5-31-2016

## Catwalk and Tower Engineering Bulletin

### Product Upgrade: Catwalk Cross Member Upgrade for #2 and #4 Catwalk Systems

#2 Catwalk Cross Member Upgrade

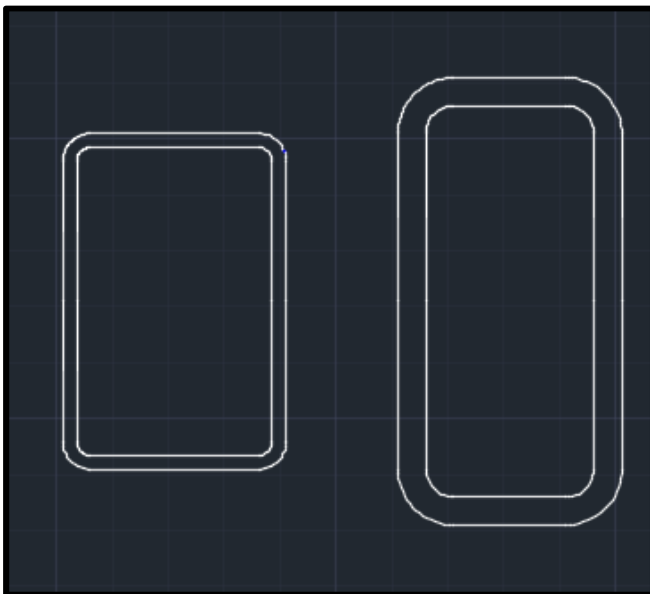
Chief Agri Industrial is pleased to announce that the cross members for the #2 and #4 catwalk systems have been upgraded. The new cross members allow for conveyors to be supported every 10 feet which is every third cross member. Prior to this, depending on the weight of the conveyor, supports needed to be placed on every cross member or every other cross member. Supporting the conveyors every 10 feet is consistent with what is recommend by Chief for drag conveyors as well as other manufacturers. Customers also prefer conveyors supported every 10' so that they can change the bottoms of the conveyors without removing supports. Catwalk package part numbers remain the same as they were before.
